**PLANNING COMMISSION SITE PLAN
COMPATIBILITY WAIVER REVIEW SHEET**

CASE NUMBER: SP-2023-0004C **ZAP DATE:** May 7th, 2024

PROJECT NAME: The Shire

ADDRESS: 2408 S 3rd St.

SITE PLAN

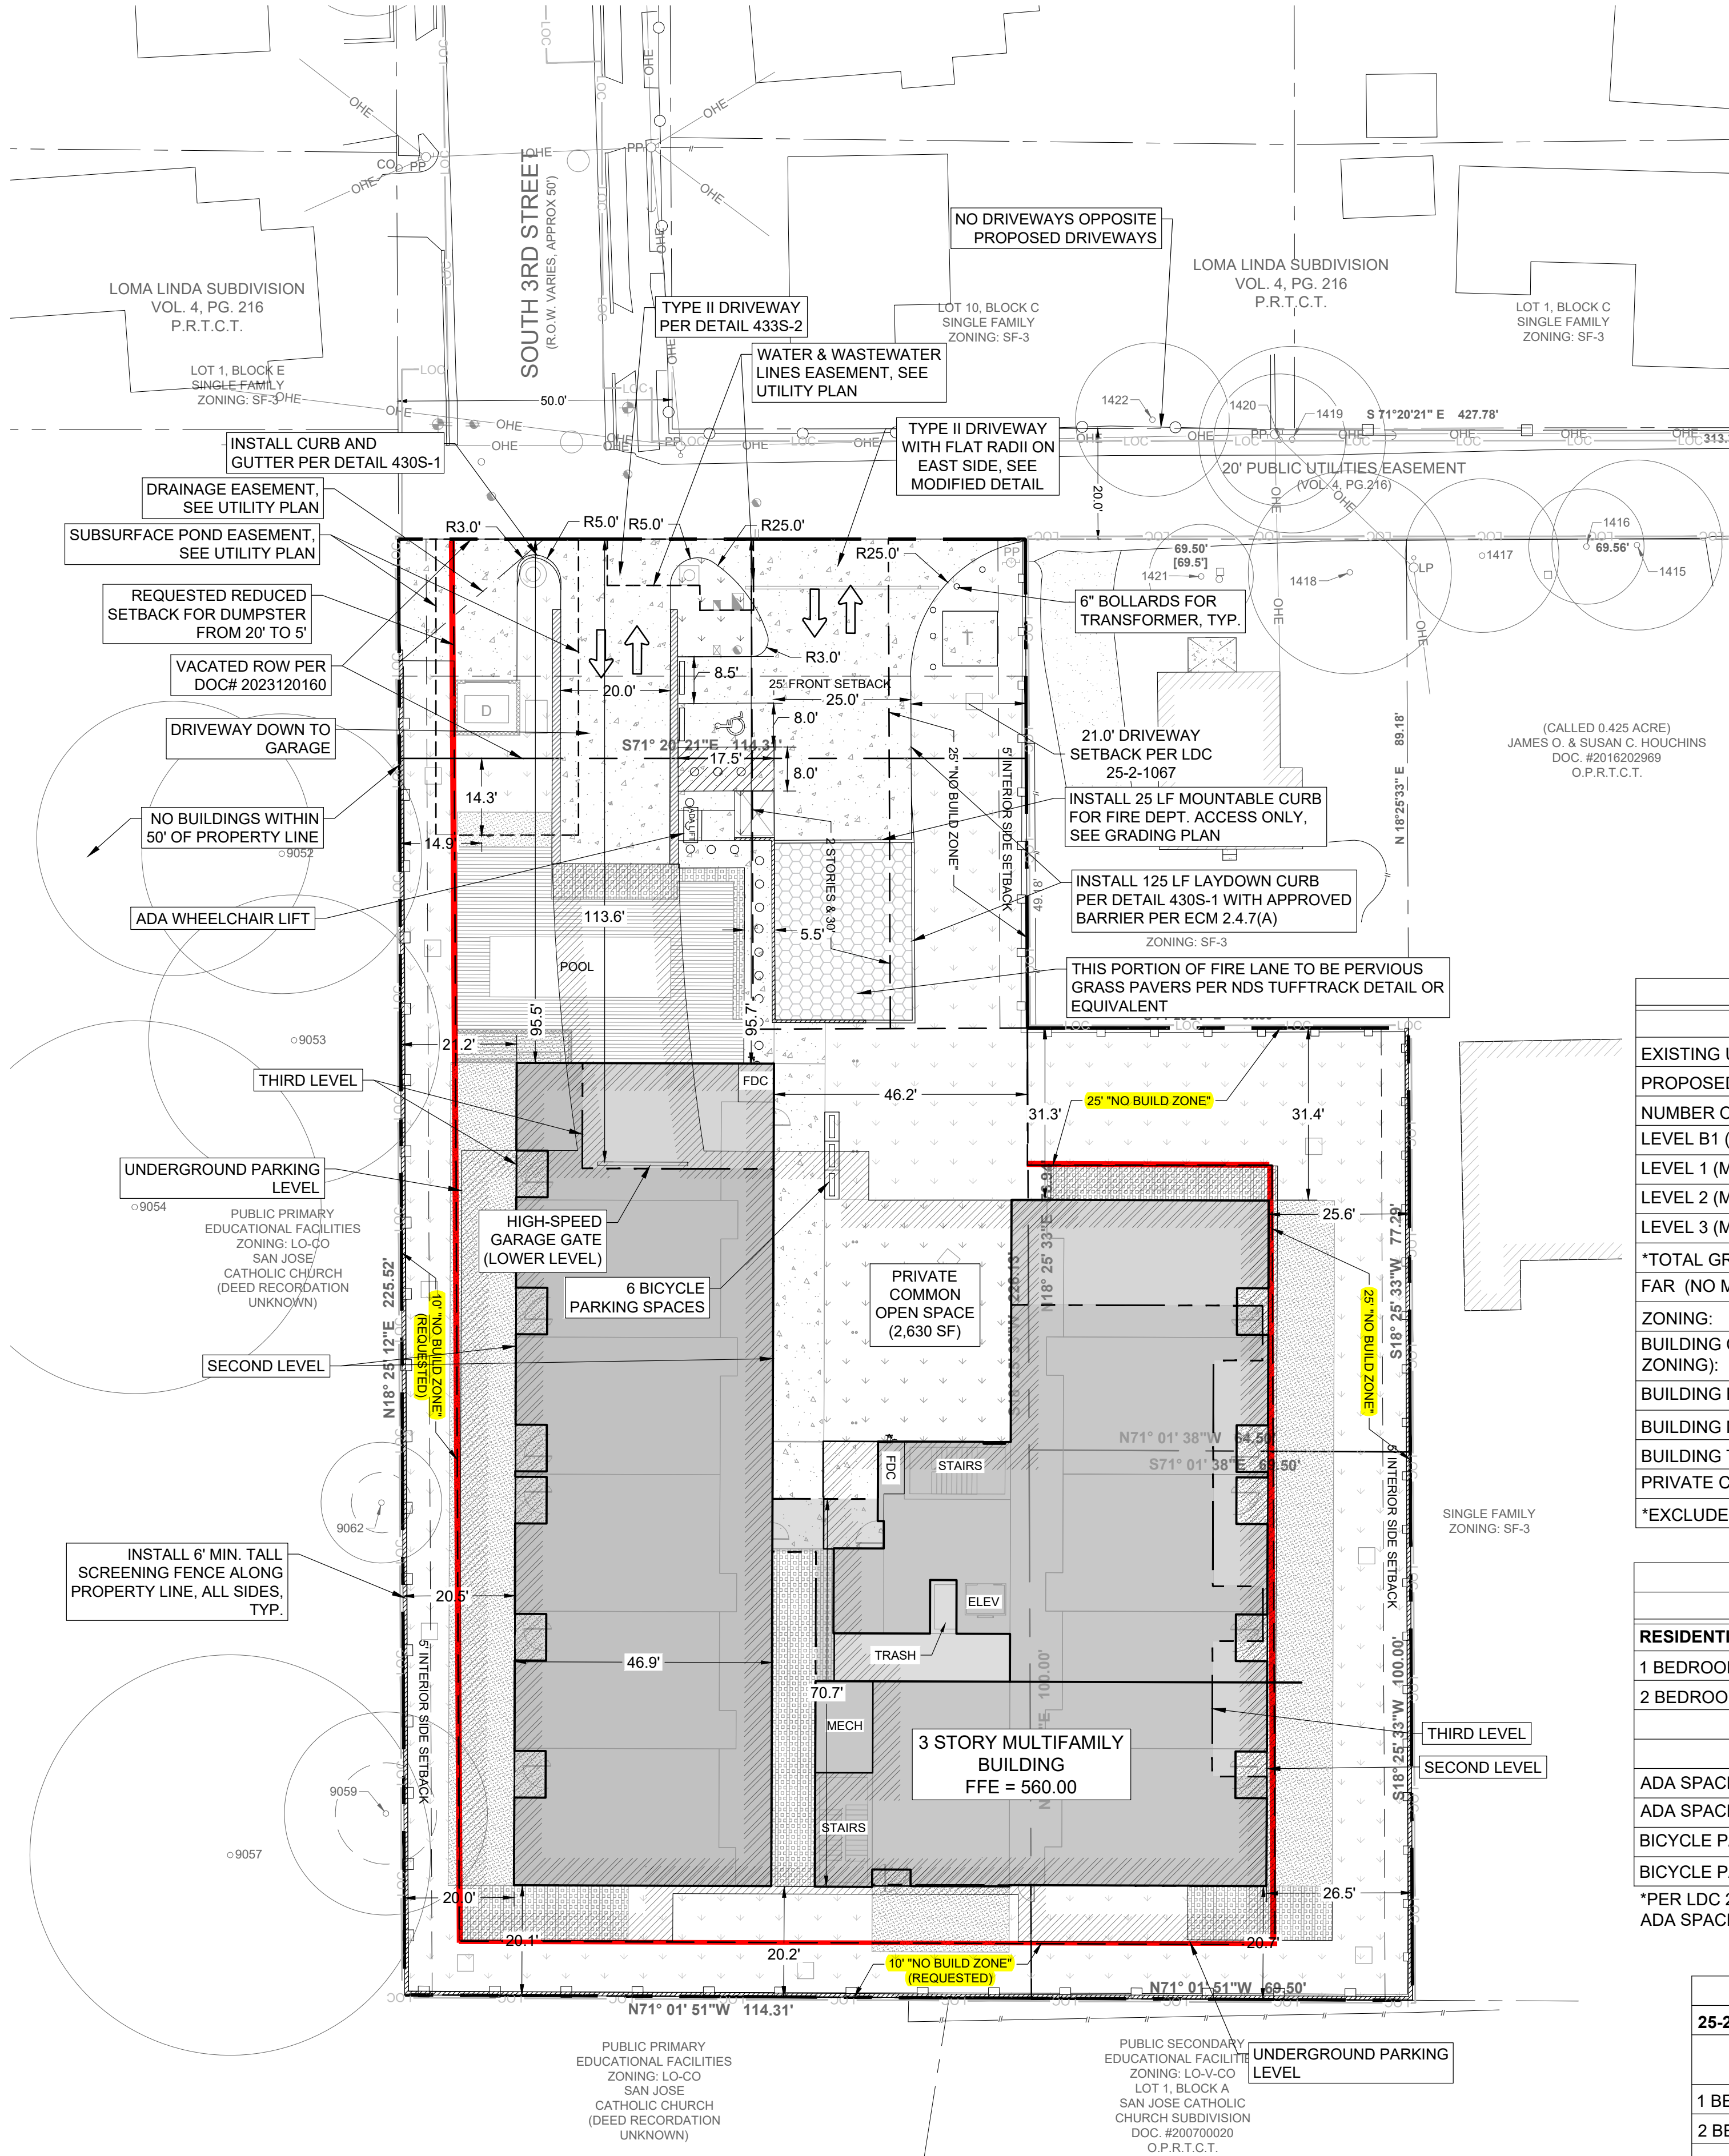
The applicant requests a compatibility waiver from a 25-foot compatibility setback along the south and west property line to the following: West: 10", South: 10'.

DESCRIPTION OF COMPATIBILITY WAIVER:

Waiver request is as follows: LDC Section 25-2-1063(B): A person may not construct a structure 25 feet or less from property:

- 1) In an urban family residence (SF-5) or more restrictive zoning district; or
- 2) On which a use permitted in an SF-5 or more restrictive district is located.

Staff recommends approval of the Compatibility Standards setback based on the unique shape of the lot. The proposed land use stays the same as the existing use and the site plan complies with all requirements of the Land Development Code.
